Type 0 Power Parameter Updates

Michael Paul

Compensation Elements

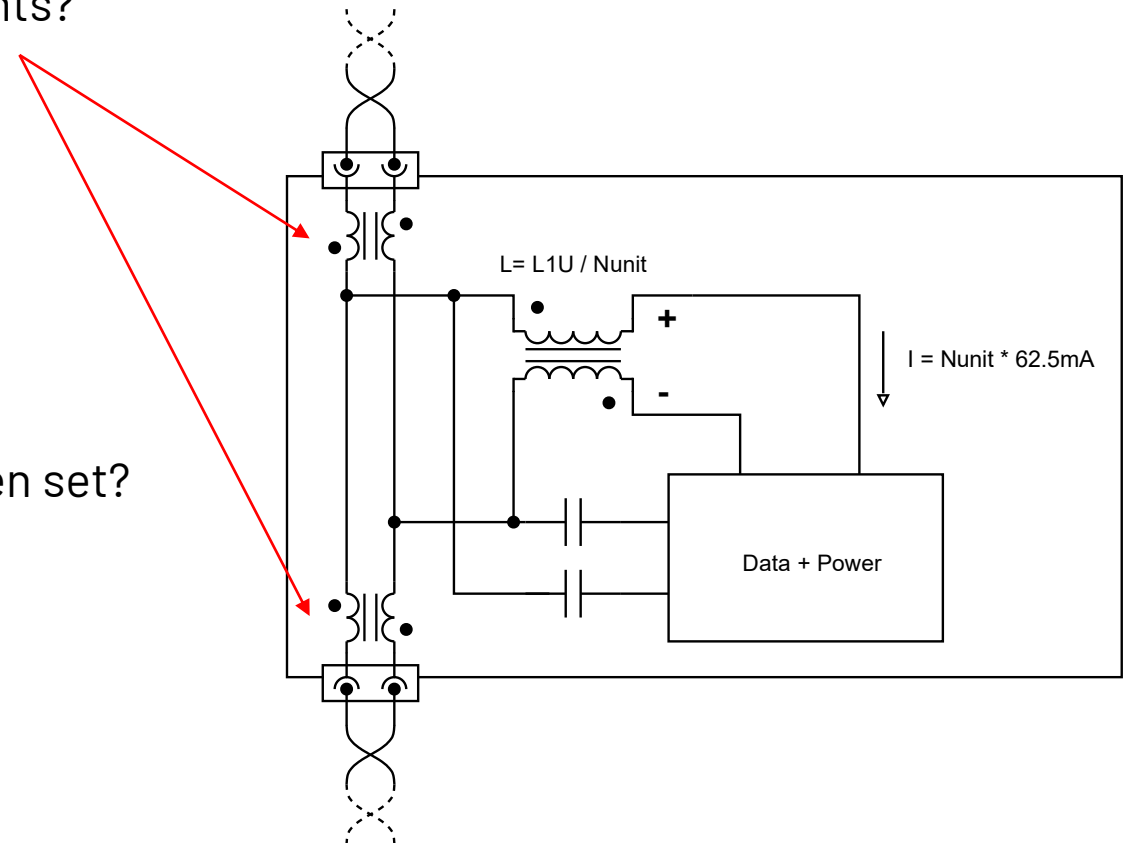
Low resistance / high current (>2A Isat) ~150nH coupled inductors are unique.

Not impossible to make, but not common yet

We need to set a target for vendors that pushes the limits, but does not push cost too hard

What is a good target resistance for these unique elements?

What is left in the budget after other parameter have been set?

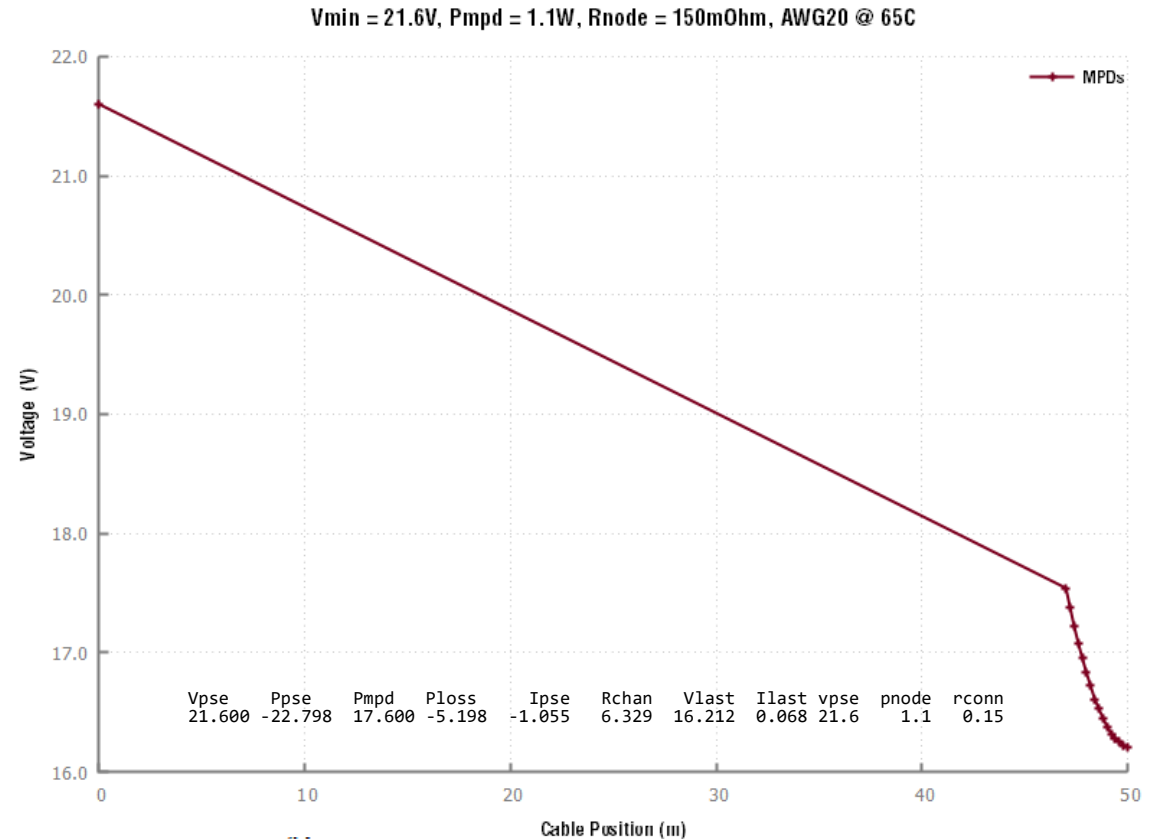
This resistance budget is based on supporting up to 17 in-line nodes (1 MPSE and 16 MPDs). Each DTE, including mated connectors and compensation components, adds up to ~~100~~ mΩ to the loop resistance.

150

Each DTE adds 150mΩ

Set resistance through each node to 150mΩ

Allocates ~75mΩ to connectors

Allocates ~75mΩ to compensators

Achieves other power deliver goals (Vmpse_type0_min, Pmpd_type0, #Nodes, 50m Reach)
